2RP-4490
DELINEATION PLAN
Antelope Tank Battery
Produced Water Spill
Eddy County, New Mexico

LAI Project No. 17-0175-37

February 23, 2018

From: [Weaver, Crystal, EMNRD](#)
To: "Sarah Johnson"; [Bratcher, Mike, EMNRD](#)
Cc: agroves@slo.state.nm.us; bcunningham@legacylp.com; [Mark Larson](#)
Subject: RE: 2RP-4490, Antelope Battery Delineation Plan, December 15, 2017
Date: Thursday, March 8, 2018 10:12:00 AM

Figure 2 - Aerial Map Showing Proposed Sample Location

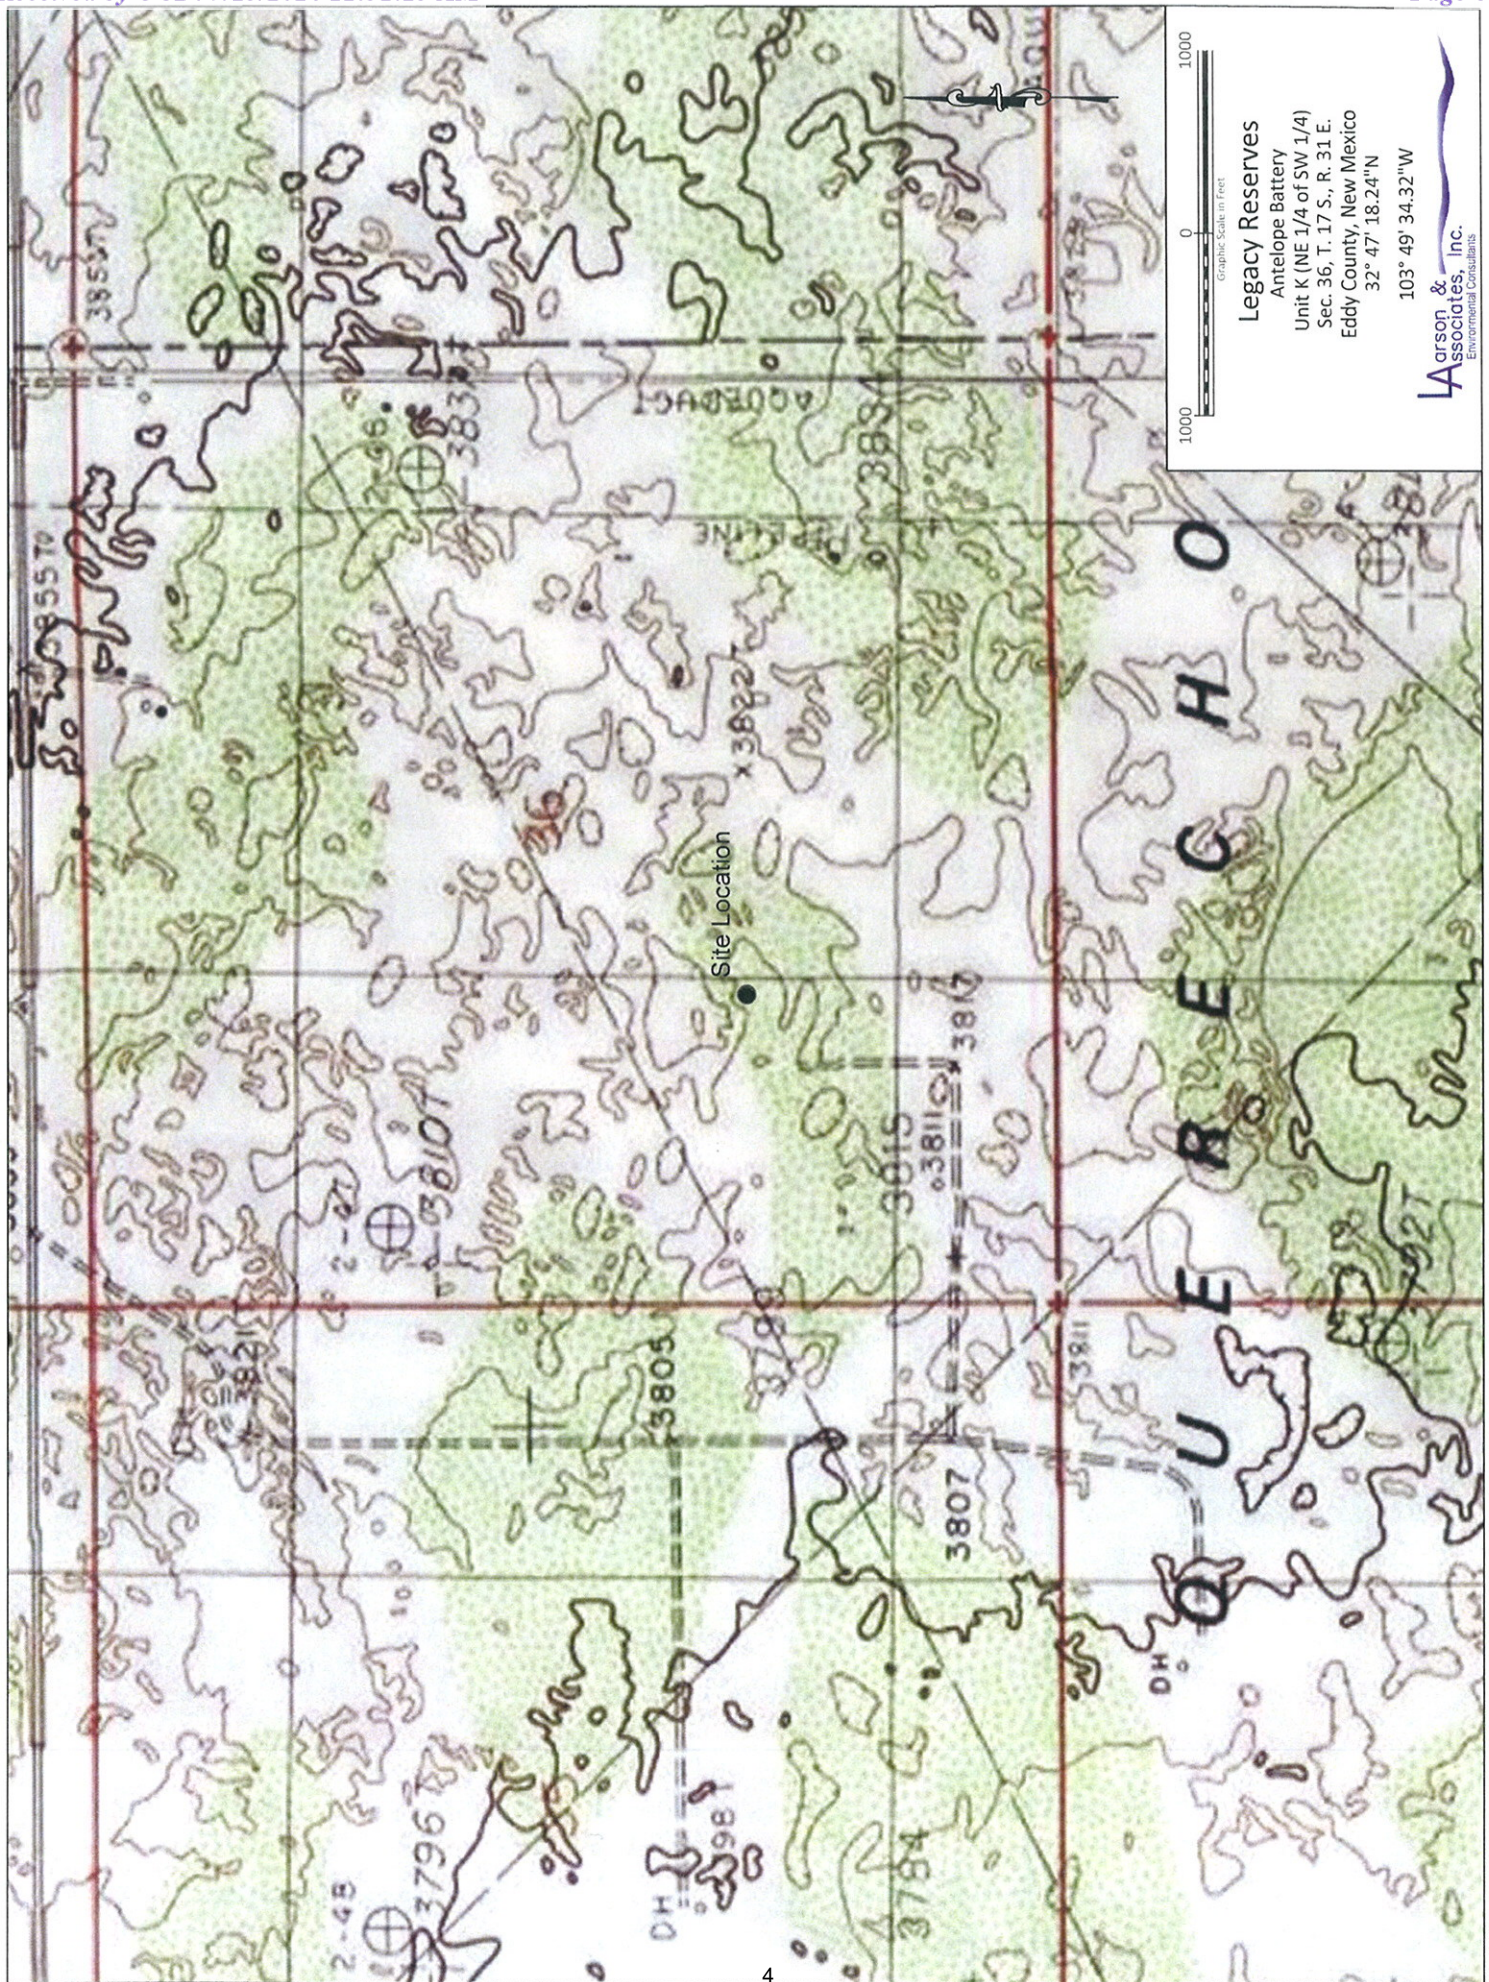
This delineation plan is approved. Delineation separation intervals of 2' after 4ft depth is reached may have to be revisited depending up data results and work plan proposal. Based on site map there is no demarcation of where the point of release occurred, therefore OCD will state this, OCD prefers that one of the delineation points be as close to the point of release as possible. Make sure to mark all tables and maps with sample name labeling when submitting actual work plan proposal.
